SR 520 - Roanoke Lid & Portage Bay Bridge

Meeting Summary

This was the SDC's second briefing of the SR 520 - Roanoke Lid and Portage Bay Bridge project design. The purpose of this meeting was to review the updated concept design for the project. After the presentation and discussion, the SDC provided a summary of recommendations for the project team to consider. The SDC will review the project again at a future date.

Figure 2: Bill Dawson Trail underbridge design proposal

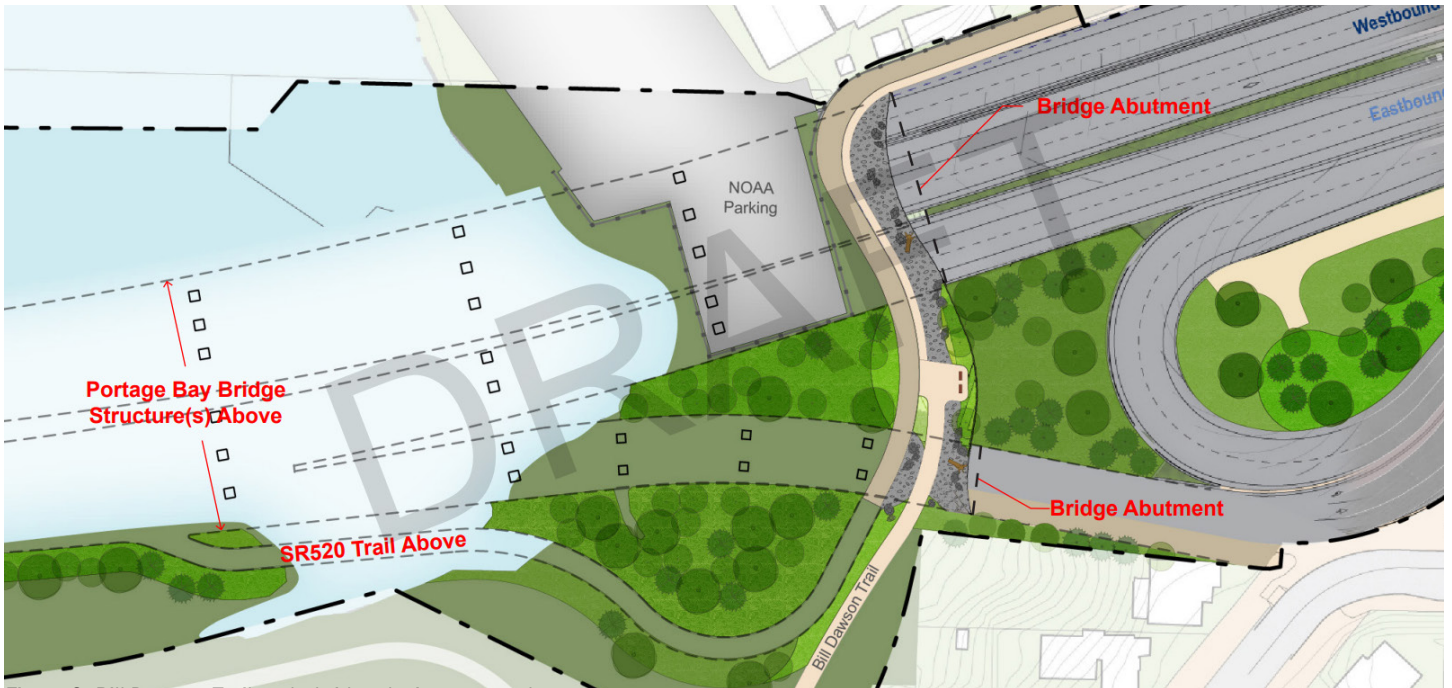
The SDC agreed the proposed design for the Bill Dawson Trail underbridge is an improvement over what currently exists, but also strongly recommended the project team consider the scale of elements proposed within the context they are located. Specifically commissioners are concerned with the scale of the proposed boulders and recommended the project team be prescriptive about the scale of specific elements as it relates to the surrounding context. Commissioners appreciated the separation of pedestrian and bicycle traffic along the Bill Dawson Trail under SR-520. They encouraged the project team to continue to explore the width and materiality of the pedestrian portion of it to elevate a sense of hierarchy of use and to provide solutions to ensure the pathway provides sufficient space for both cyclists and pedestrians. Commissioners also encouraged the project team to consider narrowing the bicycle pathway and/or striping the mixing zones to encourage cyclist to slow down. The Commission recognized the low visibility around the turn of the Bill Dawson Trail and encouraged the project team to increase the sidewalk width or to provide other options such as lighting, to improve pedestrian safety in that area.

10. Continue to explore the width and materiality of the pedestrian portion of the Bill Dawson Trail to support a of hierarchy of use and to provide solutions to ensure the pathway provides the right amount of space for both cyclists and pedestrians

11. Continue looking at alternatives in path edges and consider scale of elements, such as boulders and pavers, used along the Bill Dawson Trail underbridge to better fit with the surrounding context

12. Increase the sidewalk width and provide options to improve safety near the turn with low visibility on the Bill Dawson Trail

Figure 3: Portage Bay Bridge design proposal

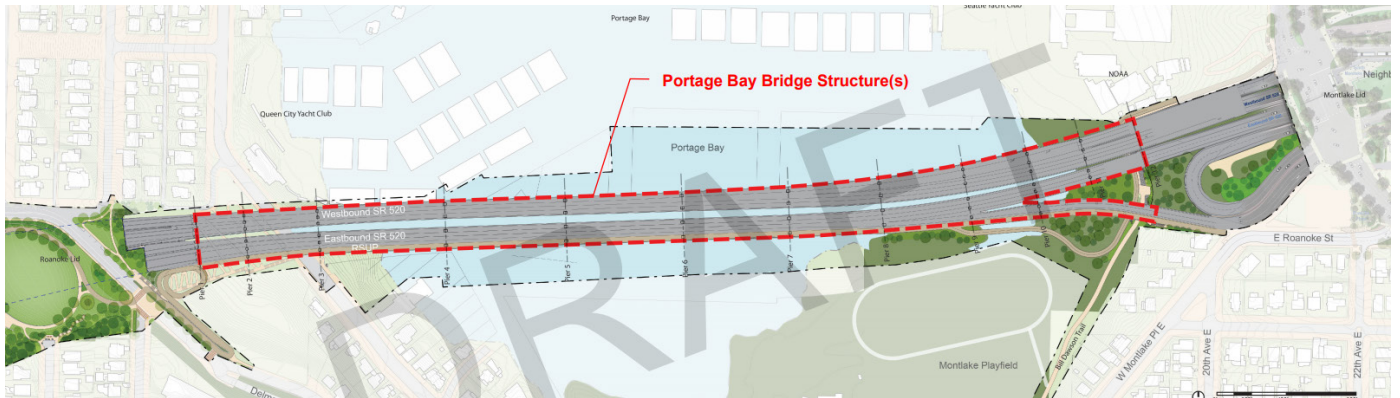
The SDC appreciated the continued work being done on the Portage Bay Bridge design. Specifically, commissioners appreciated the tapering of the piers and columns below the bridge as well as the continued breaking down of scales and creating a rhythm of different elements such as lighting, blisters, railing, and signage. The SDC strongly encouraged the project team to ensure these are represented in the final design. The Commission did not have a preference regarding the integration of the blisters and railing, but recommended the team continue to break down the scale of the bridge with specific elements and to also consider how the rhythm of each bridge elements can be integrated with one another.

The SDC then commented on the proposed lighting. Commissioners agreed the existing lighting proposal seemed out of scale for pedestrians and recommended the project team study using smaller, pedestrian scaled lighting. Encouraged the project team to consider using lighting as a gateway element and also recommended the project team compare the proposed lighting options to existing lighting conditions.

1. The SDC appreciates the tapering of pier and columns of the Portage Bay Bridge

2. The SDC appreciates the work being done to break down the scale throughout the Portage Bay Bridge design and recommends to continue breaking down scale as the project progresses.

3. Consider thinking about how to better integrate the rhythms of lighting, railing, blisters, and signage
4. Model how the one bridge and two bridge alternatives will look, especially below especially from below the bridge

5. Compare proposed lighting options against existing lighting conditions
6. Consider lighting as a special feature to serve as a gateway element
7. The SDC appreciated the connectivity into the neighborhood with distinct features of gateways and entry points along the Roanoke Lid
